SERVICE 		9
		X 89.115-26

INFORMATION FOR CHAIN BRAKE COMPL. REF. NO. 503 57 28-01 FOR THE MODELS 61, 66, 266 AND 268 WITH STANDARD FRONT HANDLE

1. Silencer

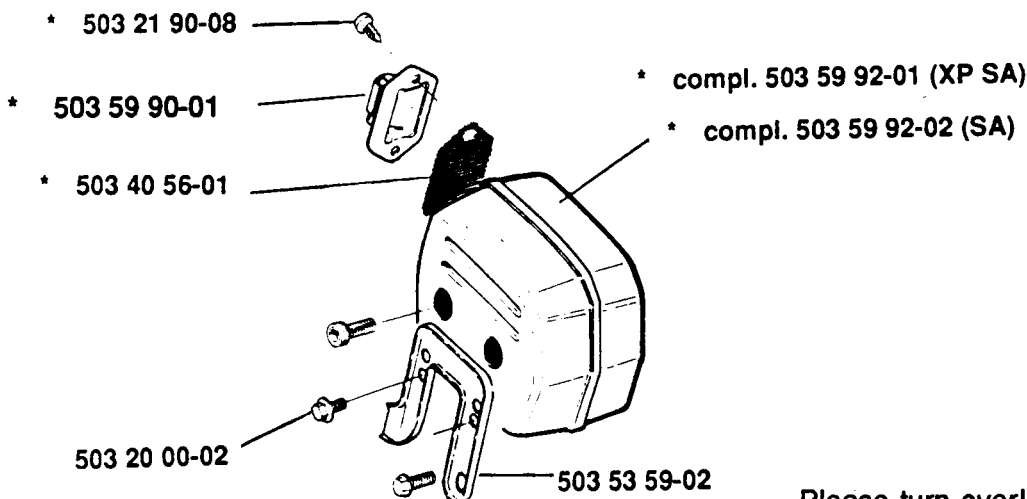
This chain brake should not be used on chain saws equipped with silencer with a so called spark arrestor and with serial number lower than 9220001 without first exchanging the following parts:

Models 162, 266: Mount silencer Ref. No. 503 59 03-01 or 503 59 03-02.
 Models 61, 66: Mount silencer Ref. No. 503 59 03-02.

Model 268: Mount silencer Ref. No. 503 59 92-01 or 503 59 92-02.

2. Spike

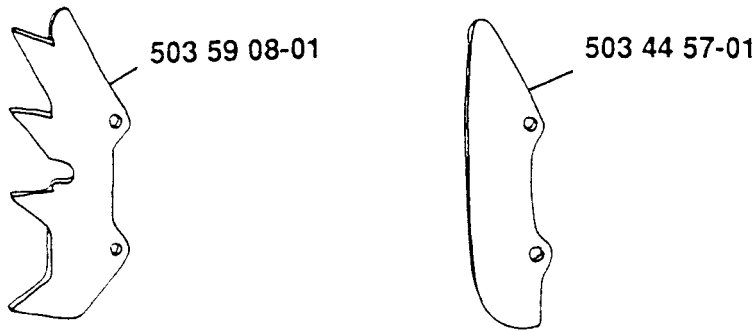
- a) Mount the inner spike Ref. No. 503 59 08-01 or a flat bumper Ref. No. 503 44 57-01.

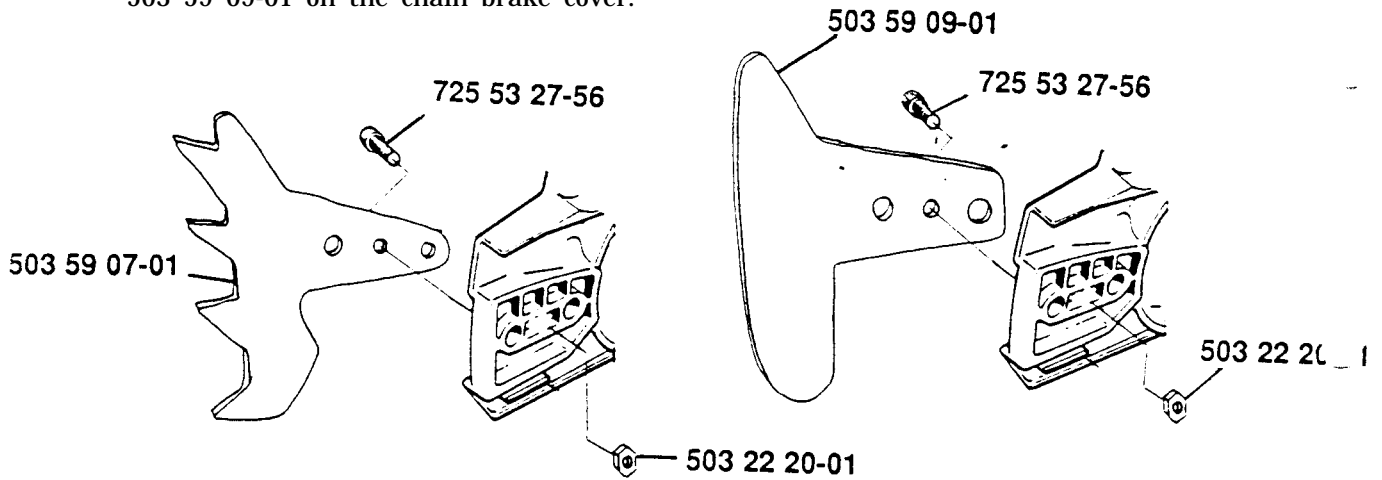
- b) Mount the outer spike Ref. No. 503 59 07-01 or a flat bumper Ref. No. 503 59 09-01 on the chain brake cover.

NOTE! Both inner and outer spike must be mounted.
